Cundy Street Quarter

# Design and Access Statement Addendum

October 2020

### Ground Floor Plan - Additional Detail and Minor Amendments

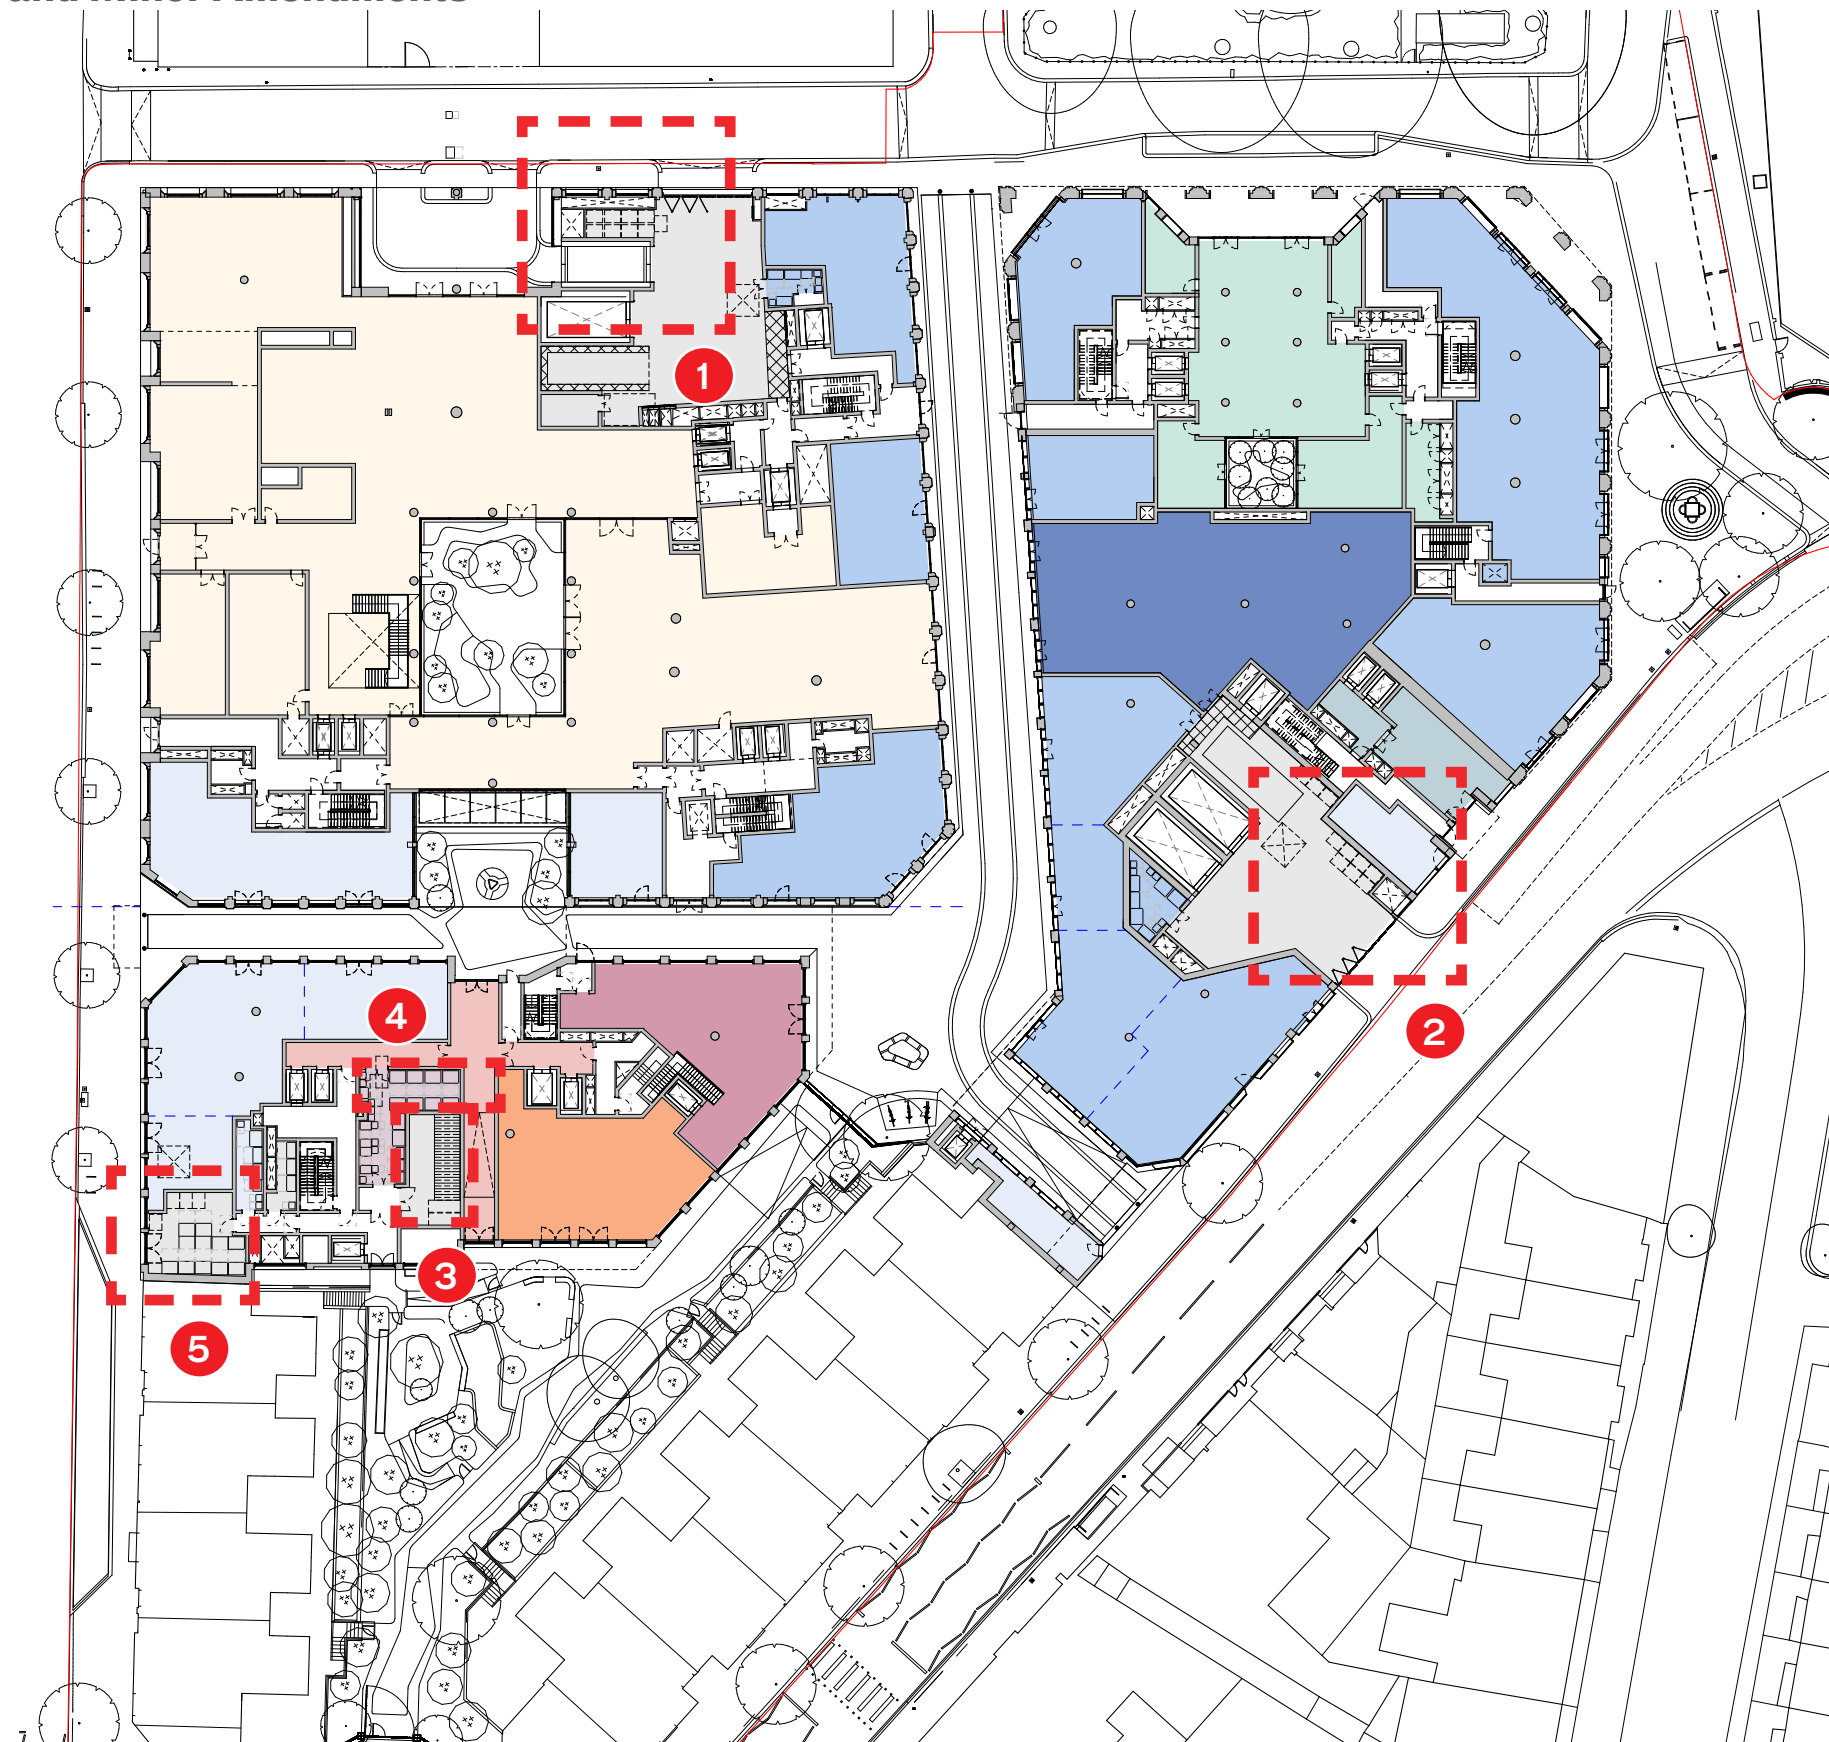
The provision of additional information has been included in the named areas below (and indicated on the plan) following Westminster City Council's request for clarity on the sizes and capacity of bins and cycle spaces for the following areas:

The only amendment required to the submitted May 2020 plan is to the Coleshill Refuse Store (5), which had to be increased in size to align with the capacity requirements in WCC's waste management recommendations.

#### 1. Building A : Loading Bay

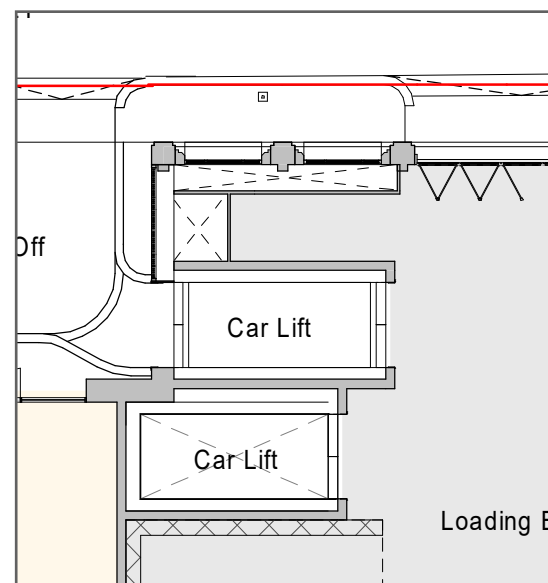
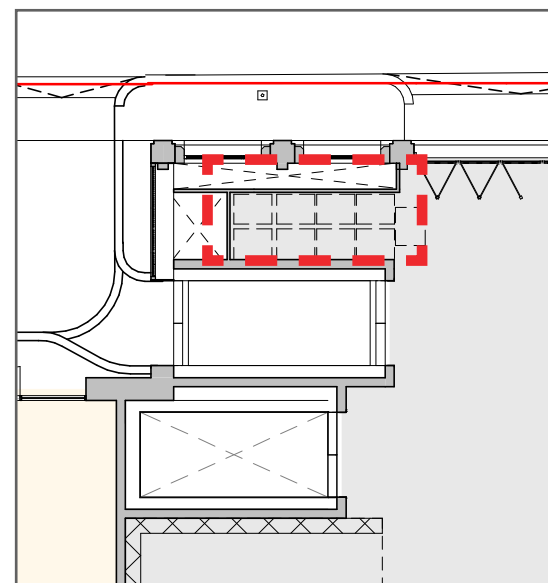
More detail added to indicate general refuse holding area at ground floor level. Layout indicates the maximum number of bins that will be collected at one point.

No changes to the general arrangement have taken place as a result of this.

#### 2. Building B : Loading Bay

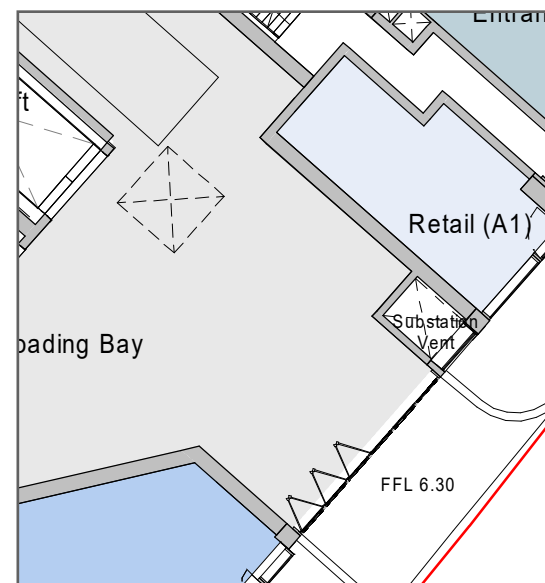
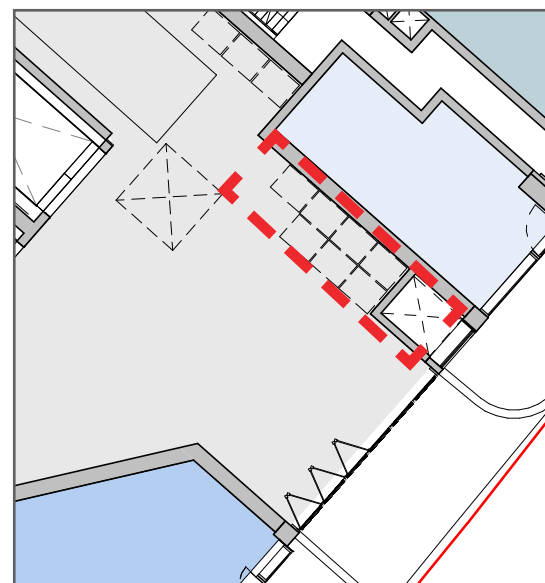
More detail added to indicate general refuse holding area at ground floor level. Layout indicates the maximum number of bins that will be collected at one point.

No changes to the general arrangement have taken place as a result of this.

#### 3. Building C : Coleshill Flats Residents Cycle Store

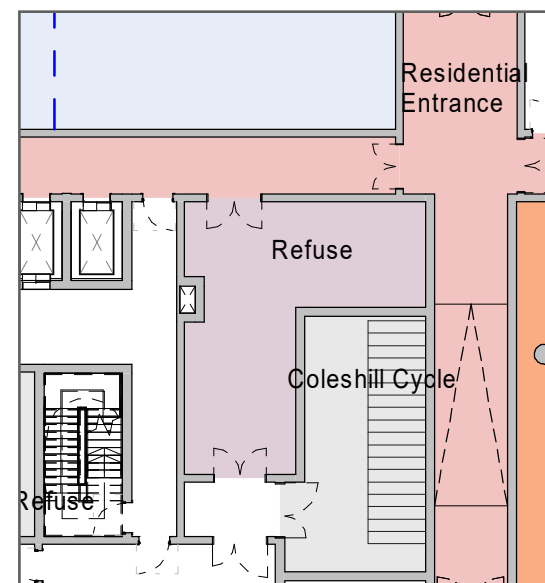
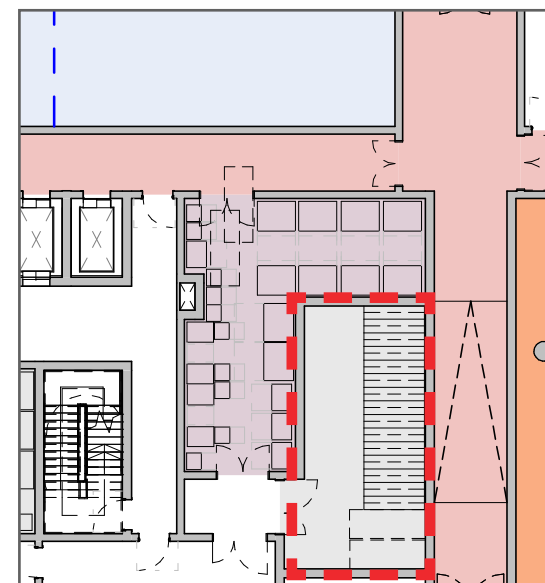
Cycle racks layout was amended in Coleshill Flats Resident Cycle Storage in Building C to provide larger cycle spaces.

No changes to the general arrangement have taken place as a result of this.

#### 4. Building C : Refuse Store

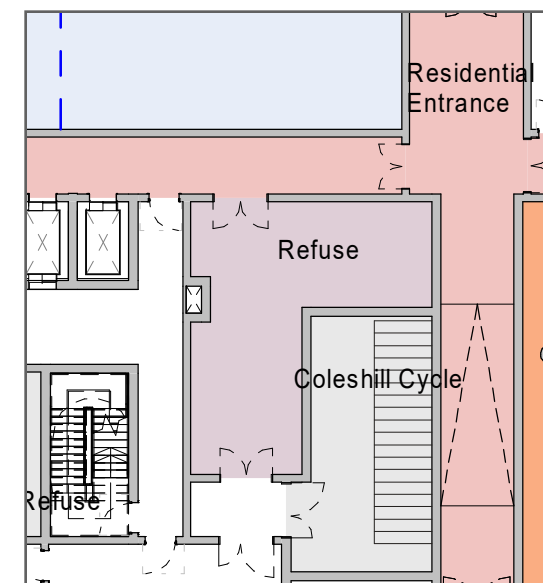
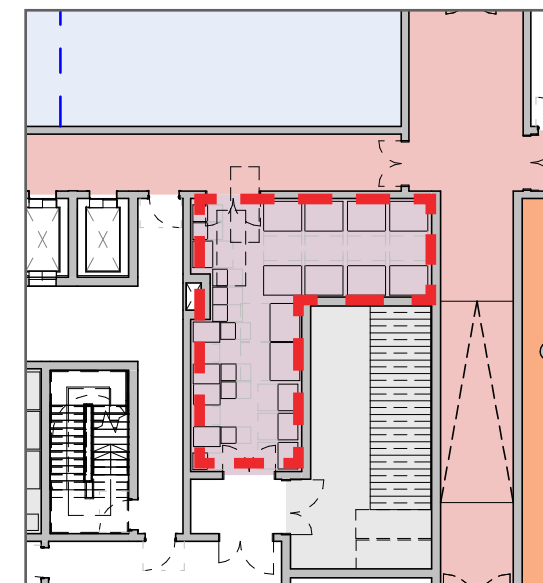
More detail added to indicate bin layouts based on a maximum capacity for general waste, recycling, food waste and waste cooking oil.

No changes to the general arrangement have taken place as a result of this.

#### 5. Coleshill Refuse Store

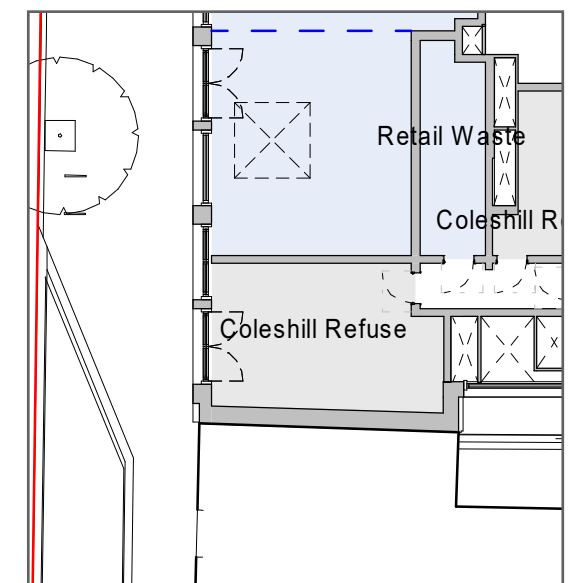
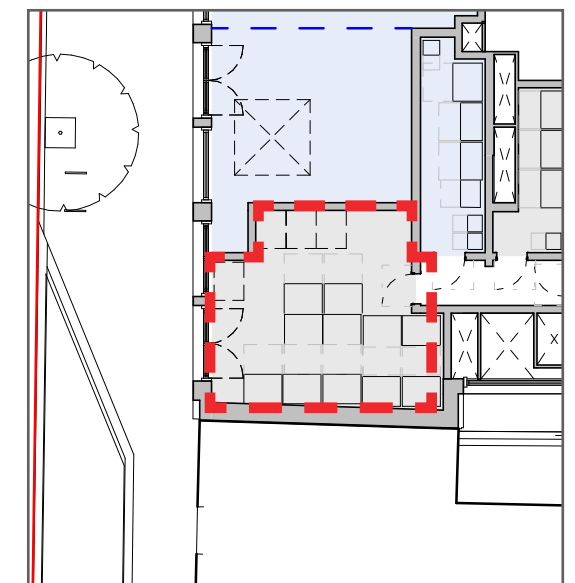
Following consultation with WCC's Waste Officer, a temporary holding area for bins located elsewhere in the building and 'bulky storage' within Building C has been proposed, avoiding the placement of such items on the pavement for collection.

To accommodate this space, Retail area was reduced.

'Bulky Storage' and temporary bin holding area included within Building C

### Basement Plan - Additional Detail and Minor Amendments

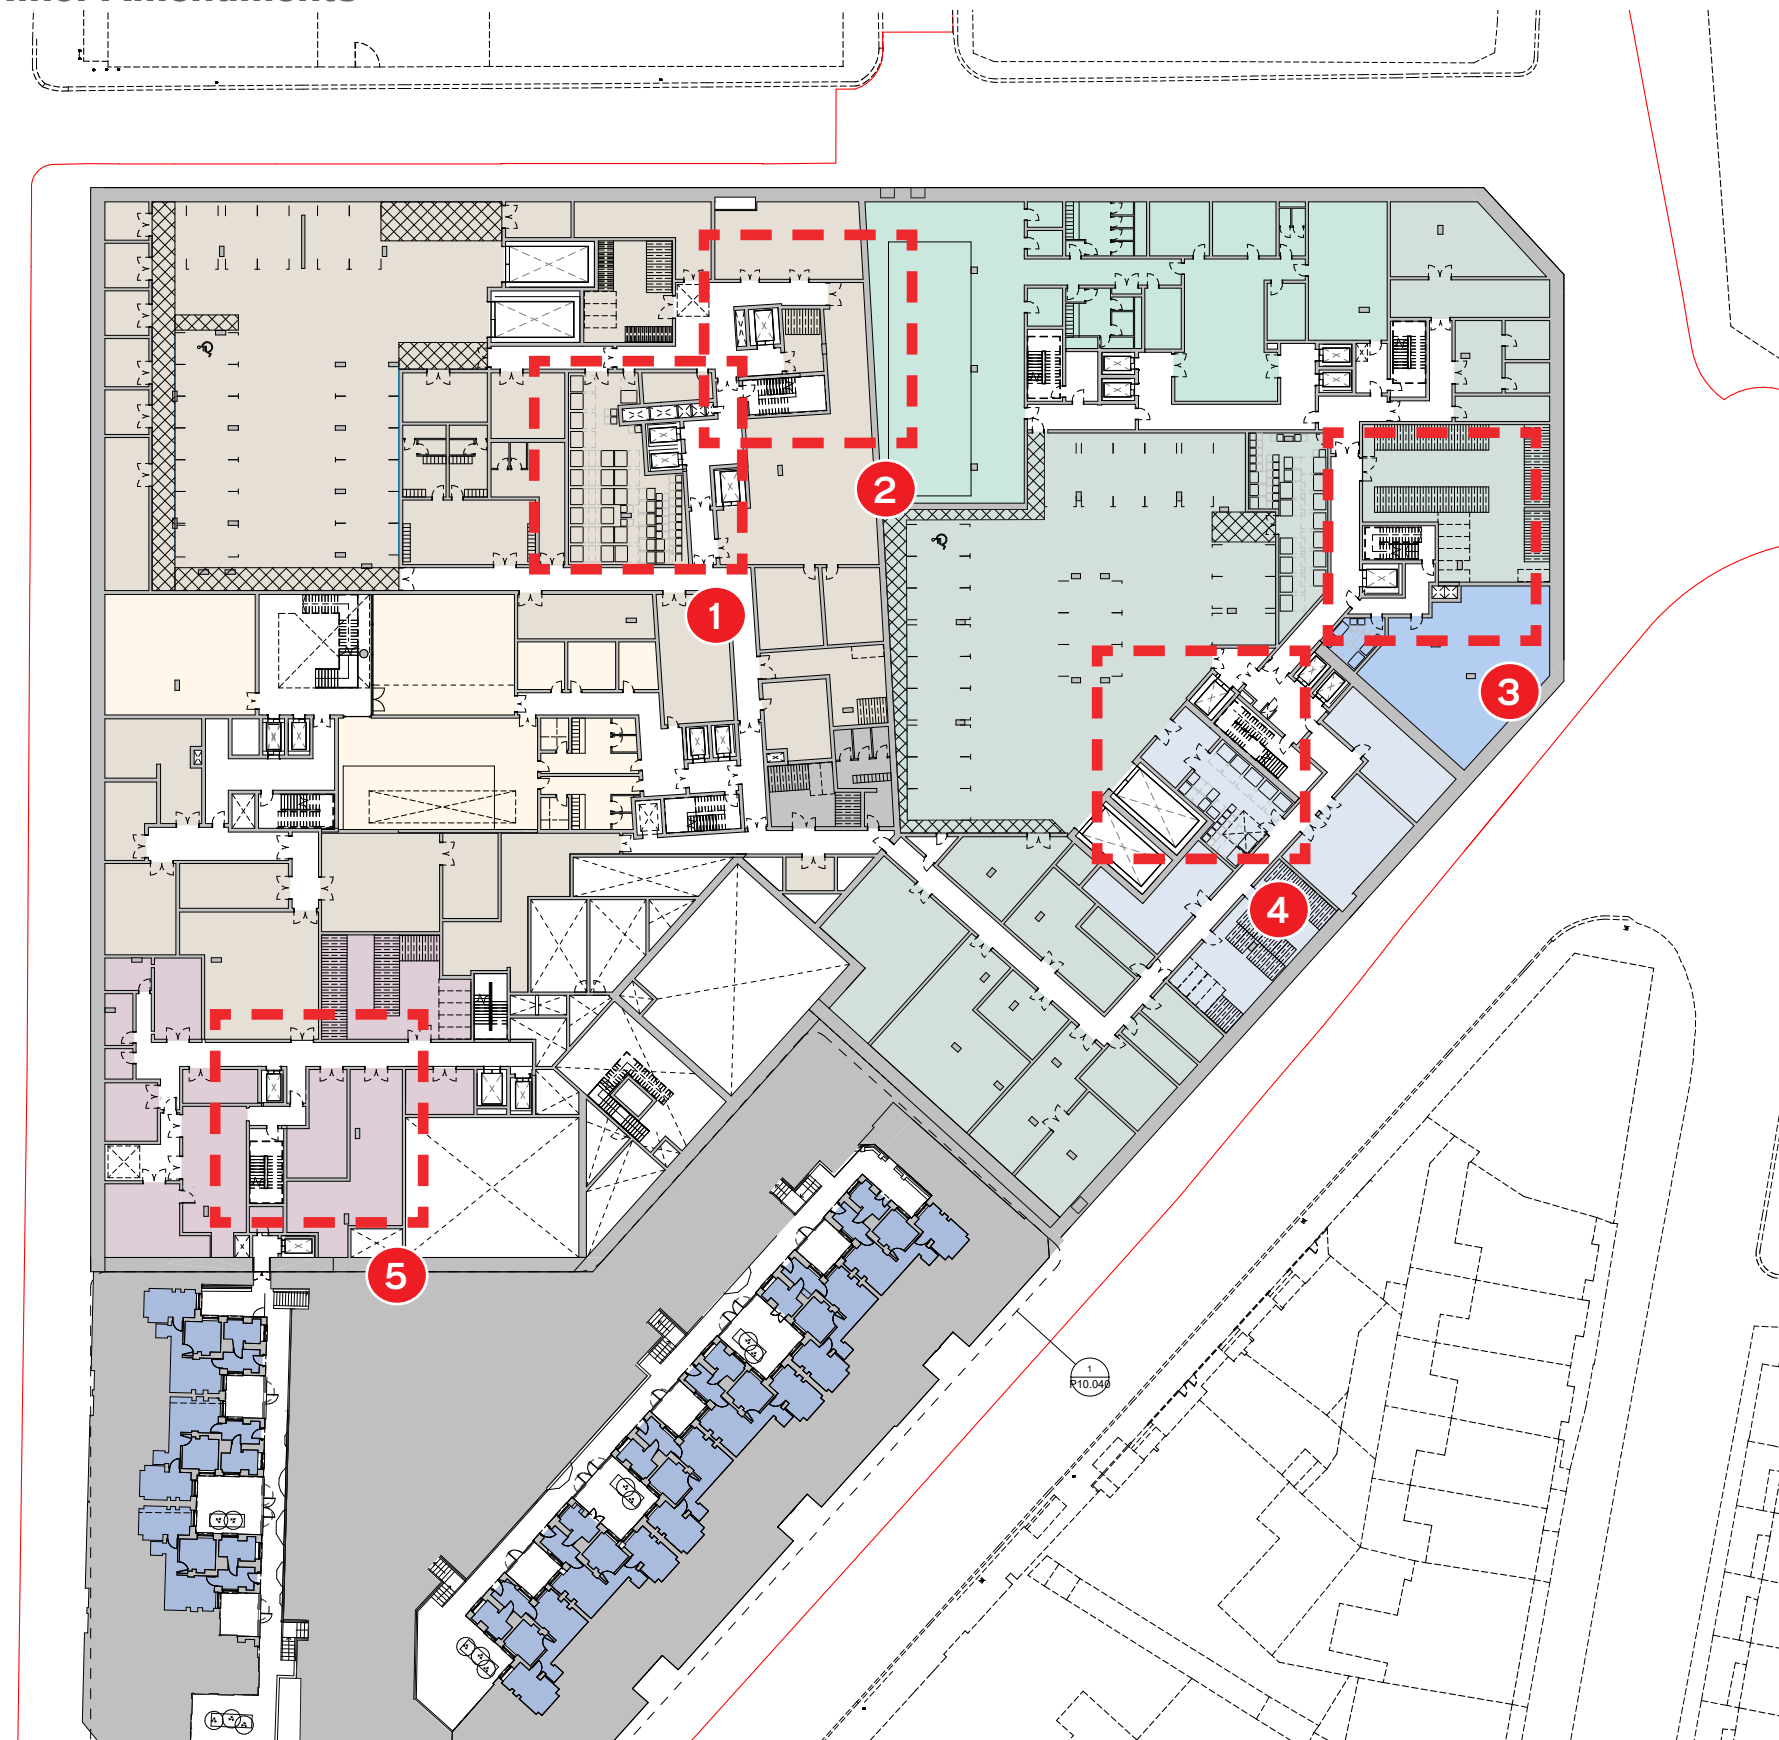
Similarly to the Ground Floor Plan, the following highlighted areas are those that have been subject to either the inclusion of additional information or minor changes based on consultation feedback:

### 1. Building A : Refuse Store

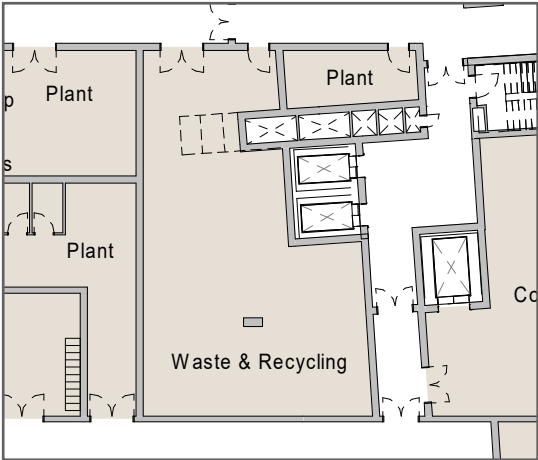
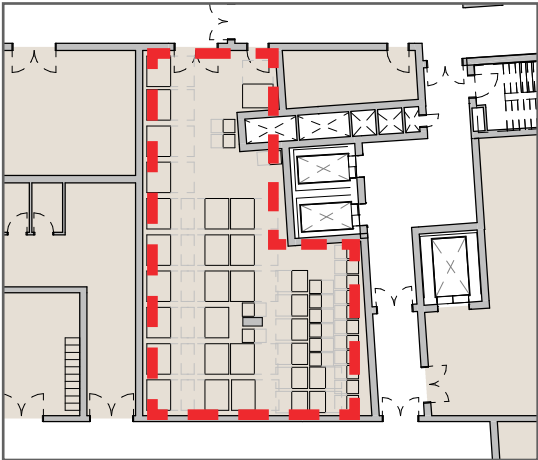
More detail added to indicate bin layouts based on a maximum capacity for general waste, recycling, food waste and waste cooking oil.

No changes to the general arrangement have taken place as a result of this.

### 2. Building A : Bike Store

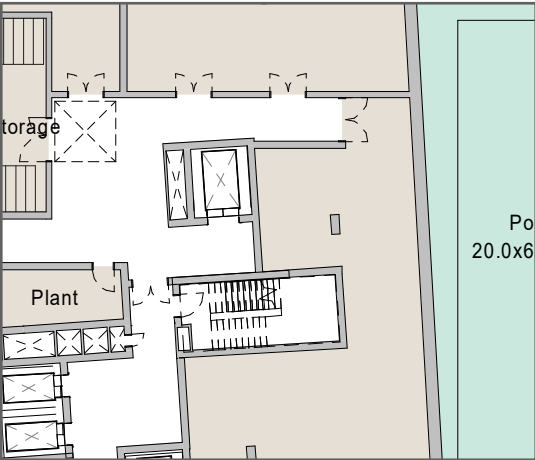
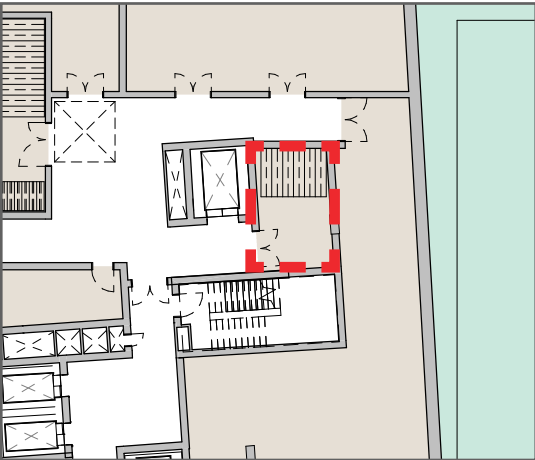
Minor amendments to internal cycle store layout in response to GLA comments for cycle spaces to comply with TfL London's Cycling Design Standards. As a result, more cycle racks and space for larger bikes are now provided.
